SUBJECT: SUPPLEMENTAL STAFF REPORT FOR HISTORIC DESIGN REVIEW CASE NO. HIS19-38: PROPOSAL FOR RETAINING WALL AT THE BENJAMIN F. HARDING HOUSE

A LANDSCAPE WALL REPLACEMENT PLAN (PH. 1)

Revision (8) 15-October, 2019

L-2

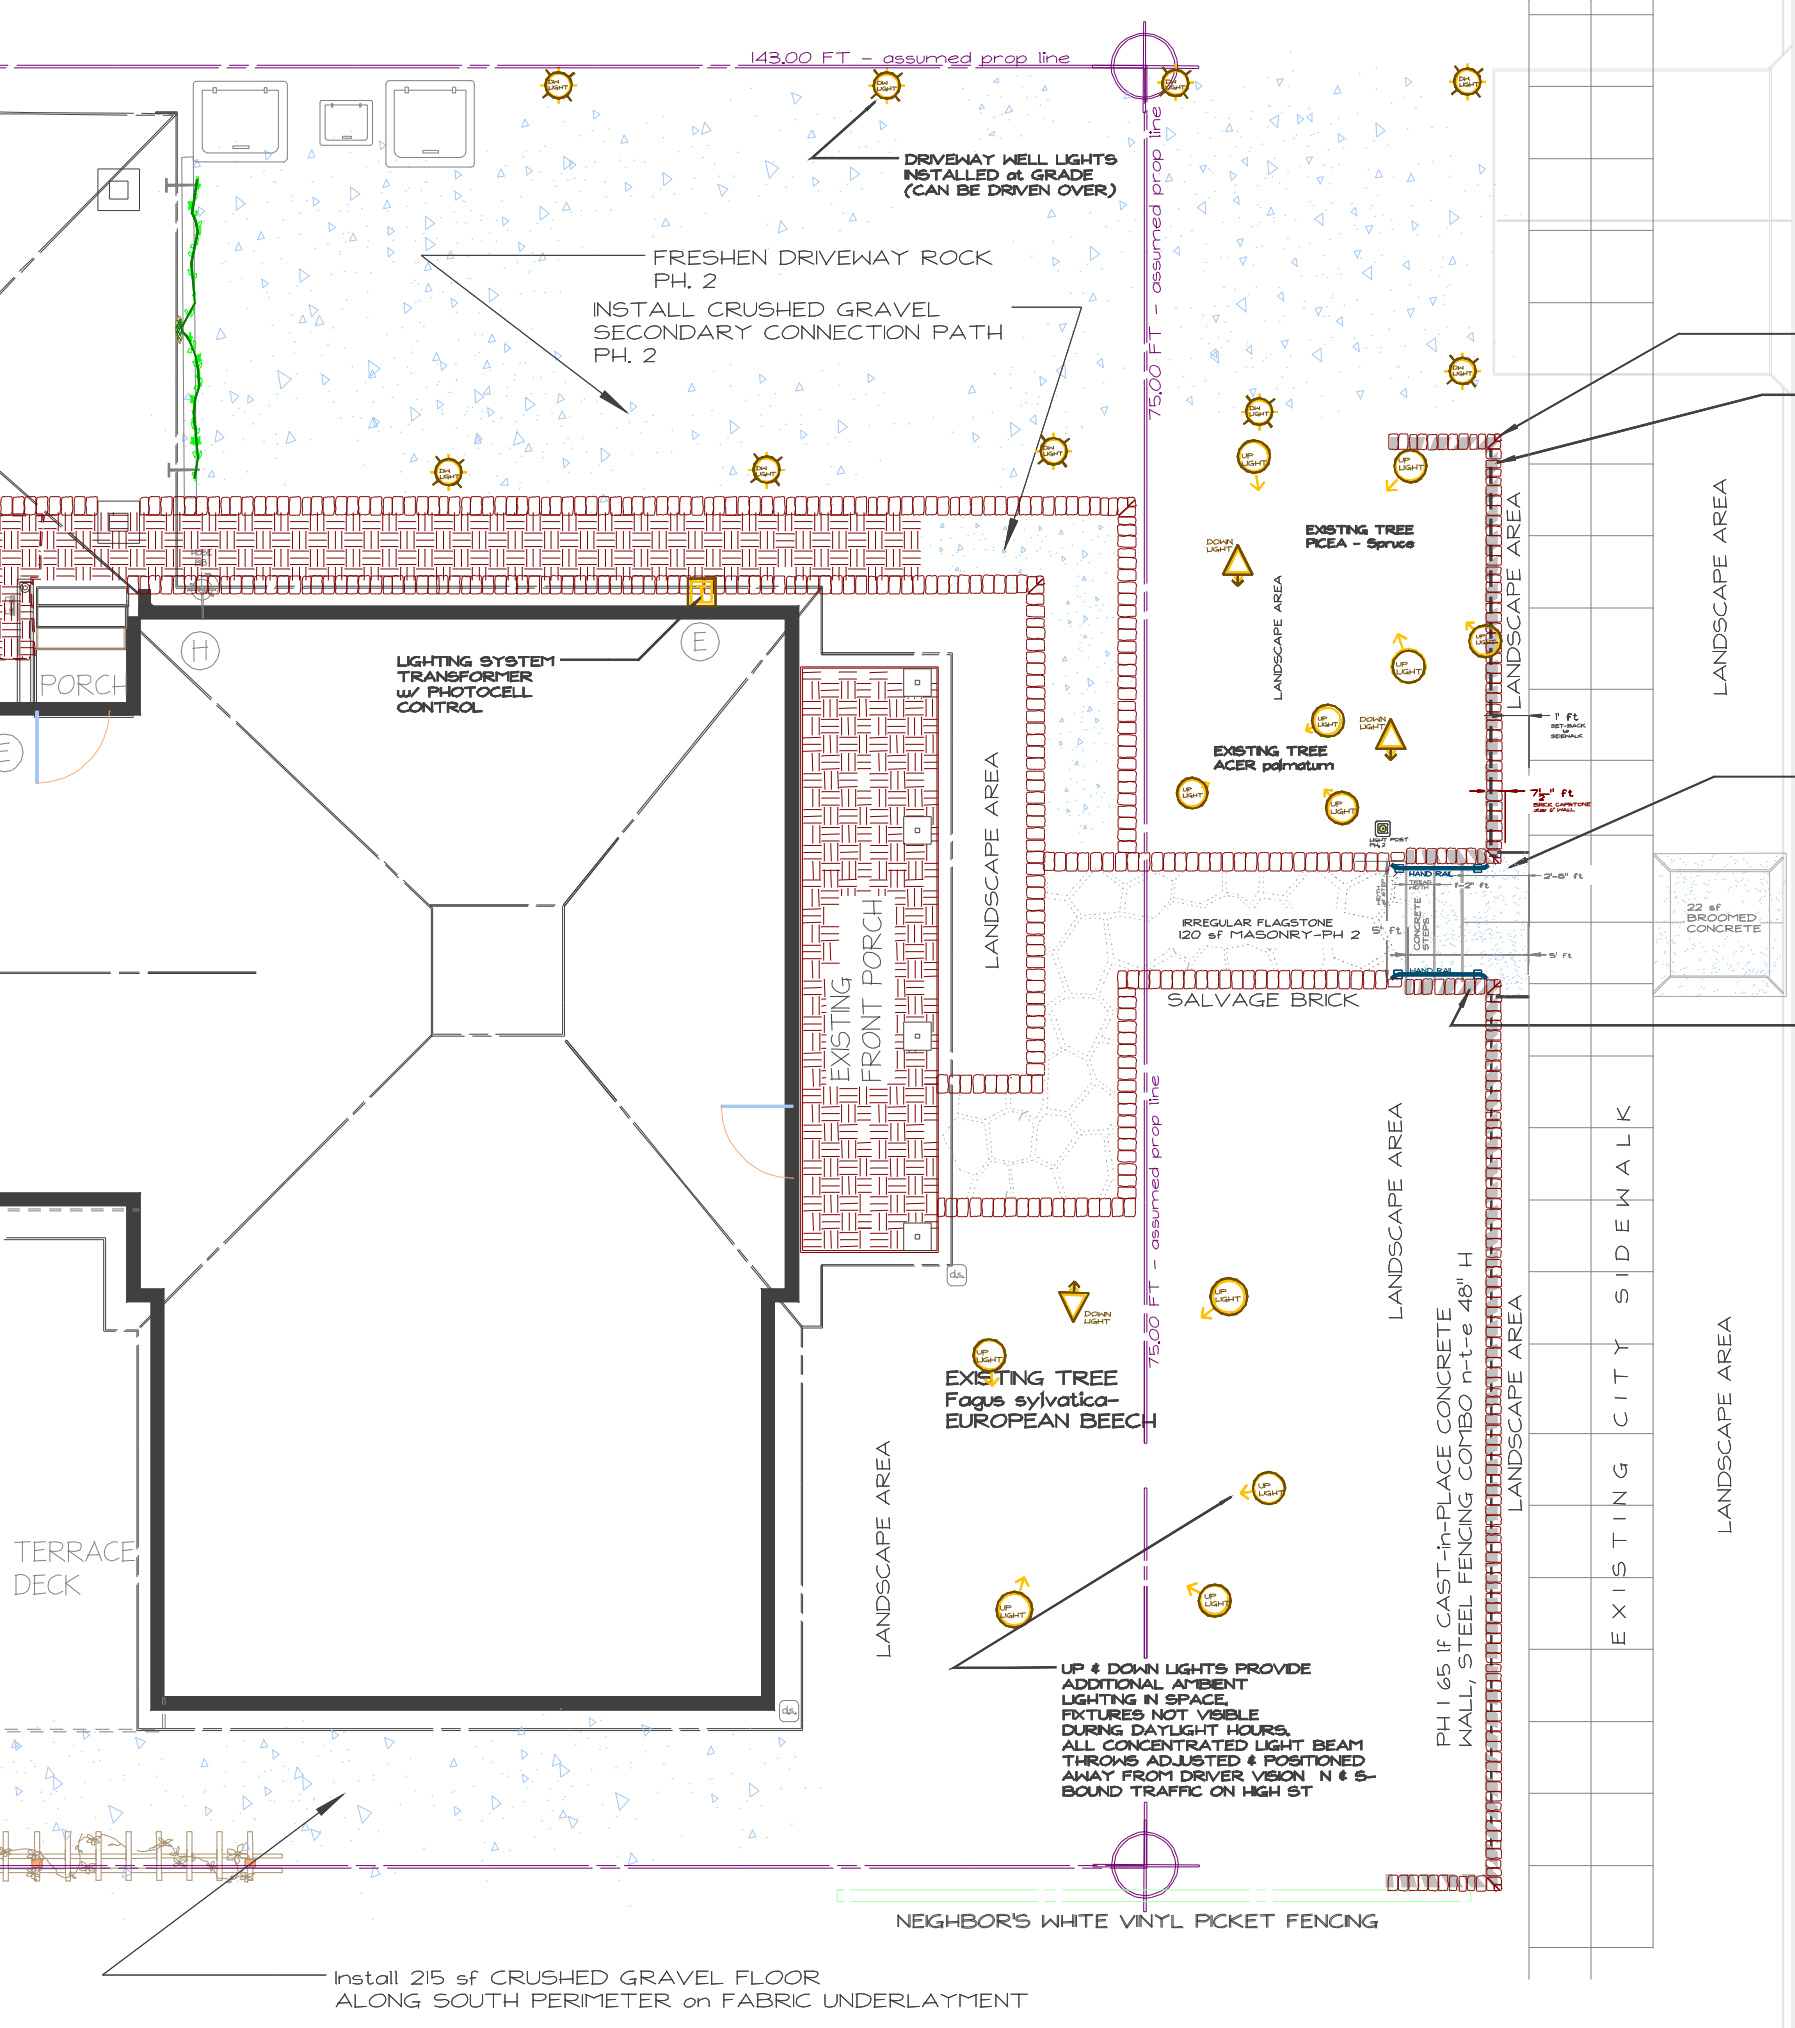
Subsequent to our earlier communication, concern has been raised to the cap lighting and a request made for clarification of illumination and details.

Any clarification or supplemental information on the illumination and cap lighting from the applicants and designer would be most appreciated.

We object to the use of under wall cap and post and rail lighting along the new retaining wall. There is nothing historic about this, and will stick out glaringly in the middle of the block where there is no other lighting.

The under-cap lighting was initially proposed solely for the wall area on each side of the front steps that come up from the sidewalk. However, after full review that lighting concept was dropped as inadequate for nighttime safety because the under-cap area at the top of the short wall is below the top-most step so the top step would be in the dark.

(Note: The removal of the detail on the drawings about the under-cap lighting beside the steps was overlooked - our yard designer has been asked to remove the reference and I expect to get the revised document today so that it can be forwarded to Kimberli.)

In place of under-cap lighting we propose to install soft LED down-lighting mounted on the underside of the step's handrails - invisible during the day but revealing the steps after dark. We do not want to re-install post lighting that is ground mounted. We have had that type of lighting in place for some years and it was a frequent target for vandalism and quickly became a nuisance to maintain.

PH 2 HIDDEN STRIP LIGHT BENEATH HAND RAIL; NESTED INTO BOTTOM OF RAIL

L-2

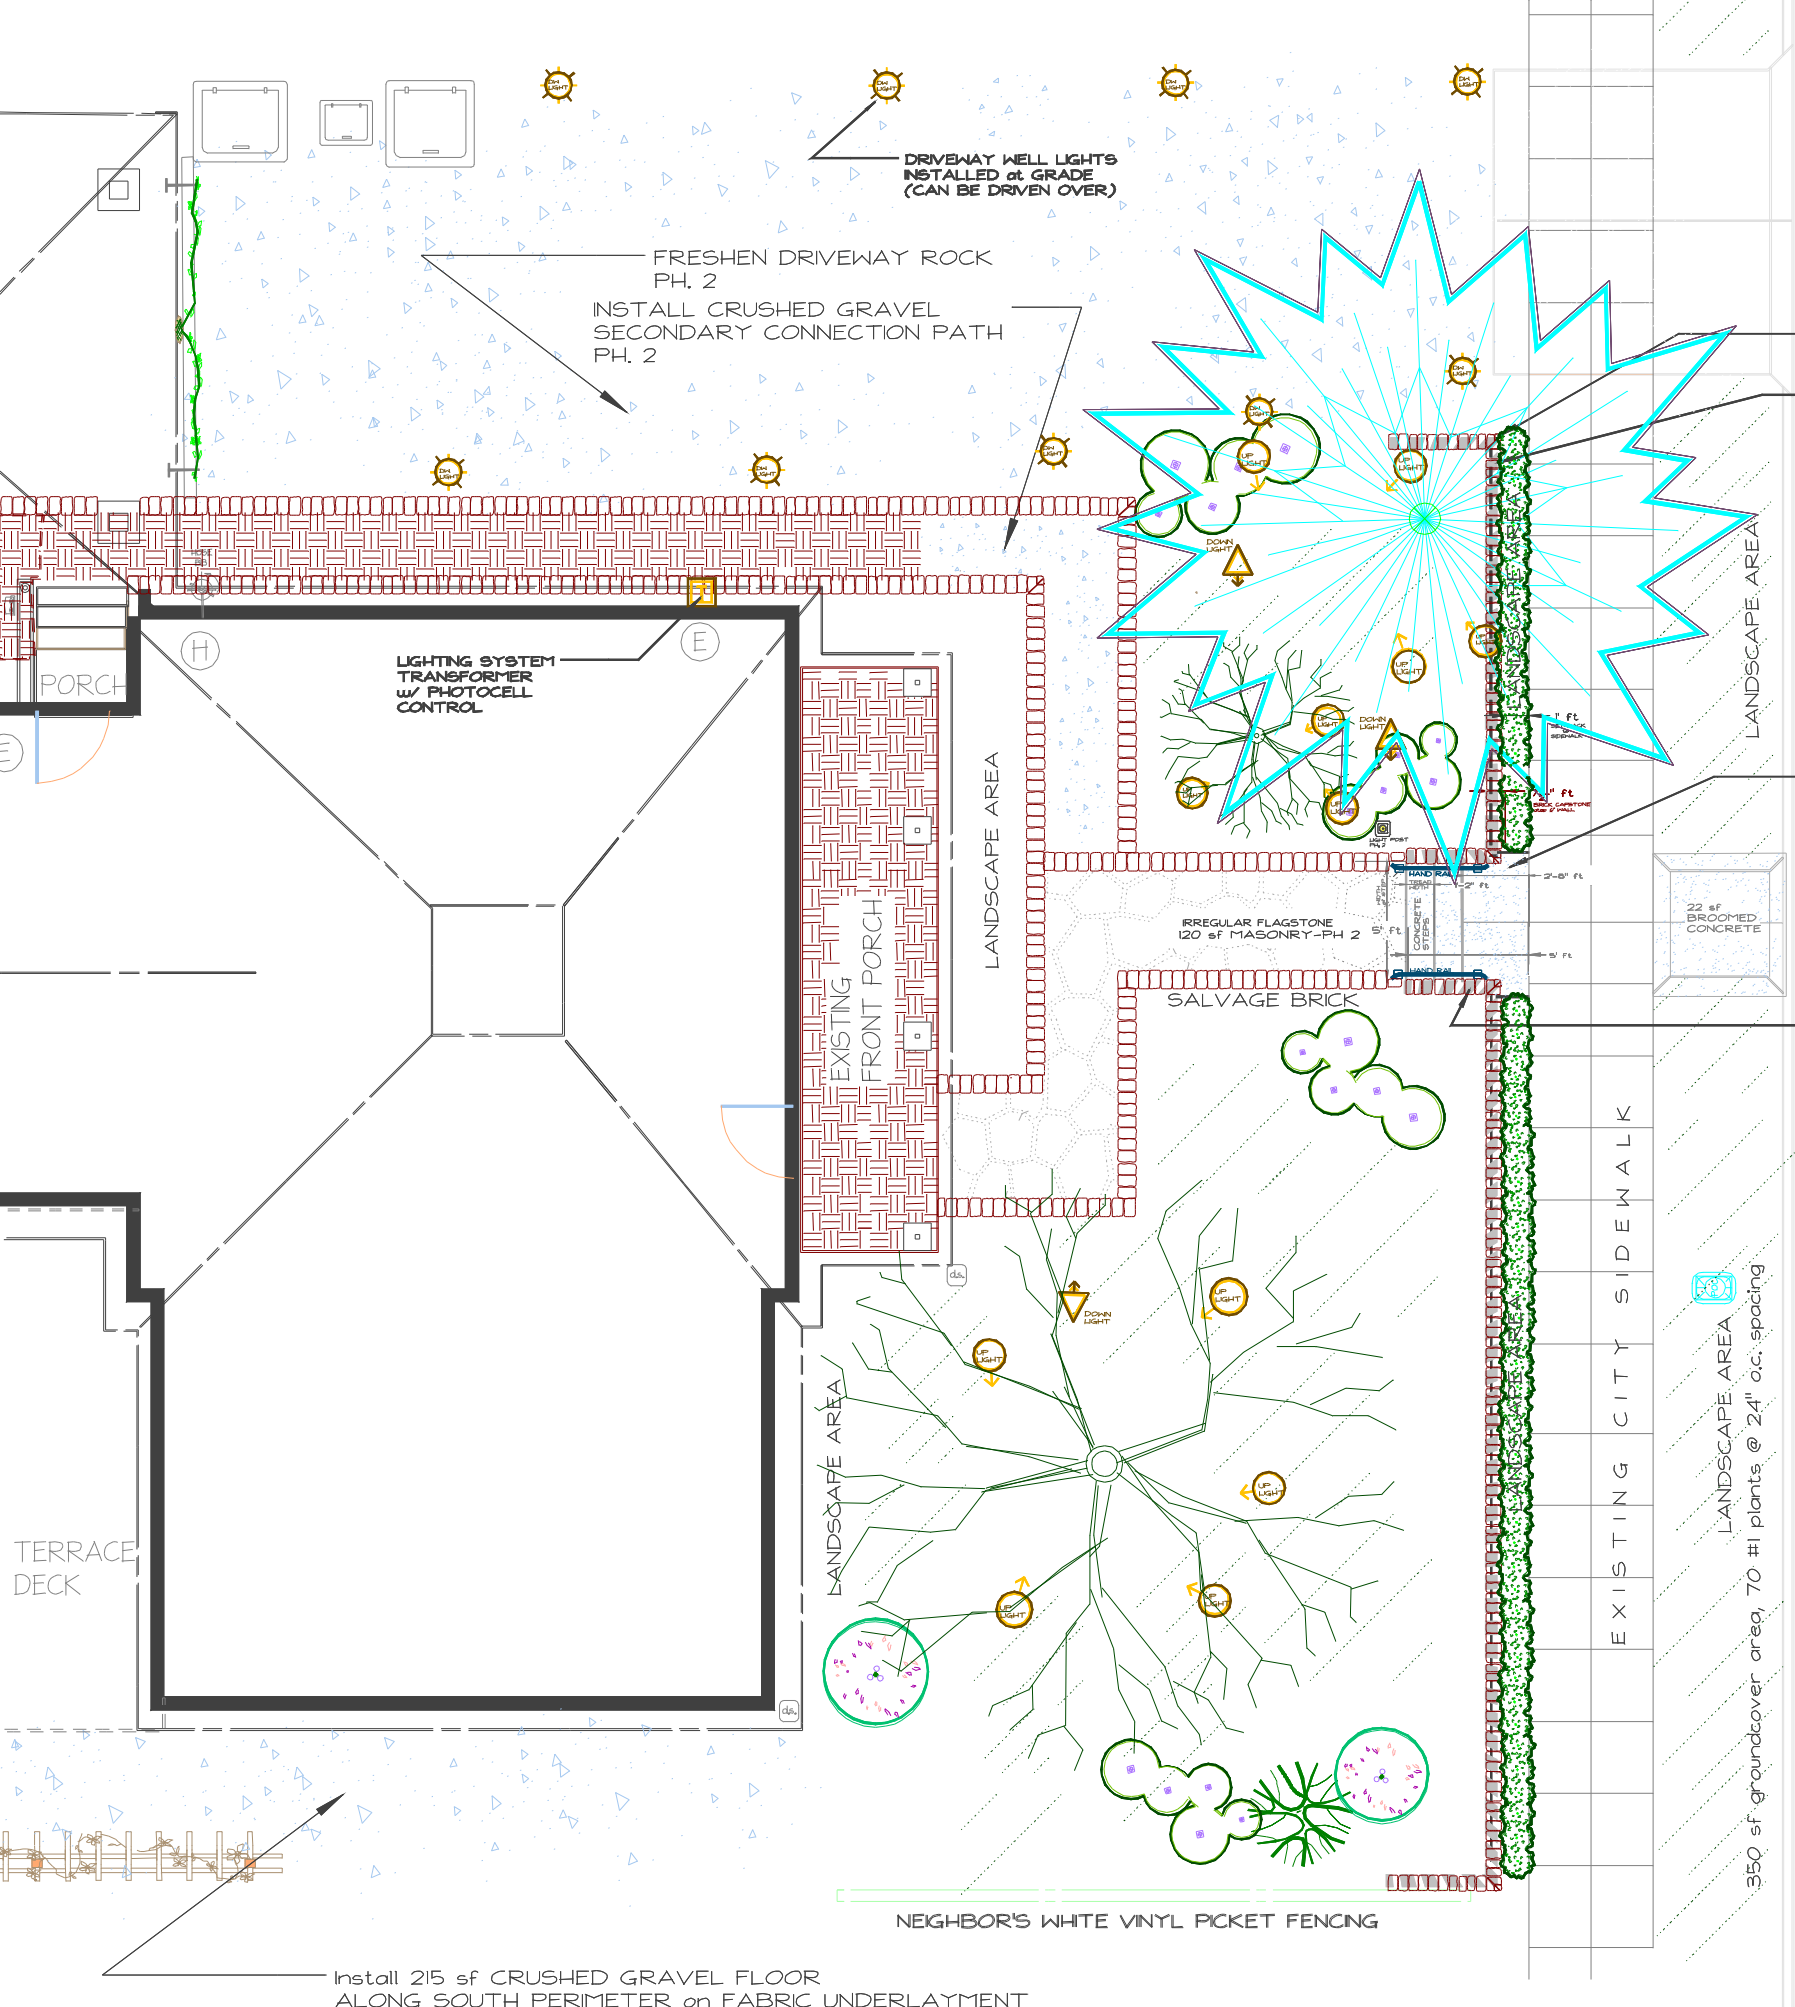
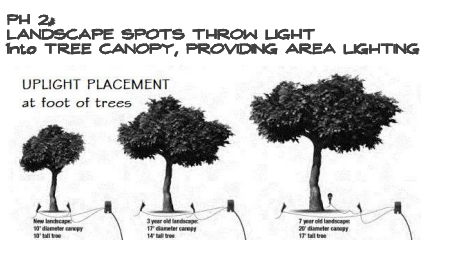
Subsequent to our earlier communication, concern has been raised to the cap lighting and a request made for clarification of illumination and details.

Any clarification or supplemental information on the illumination and cap lighting from the applicants and designer would be most appreciated.

PH 2
HIDDEN STRIP
LIGHT BENEATH
HAND RAIL
NESTED INTO
BOTTOM OF RAIL
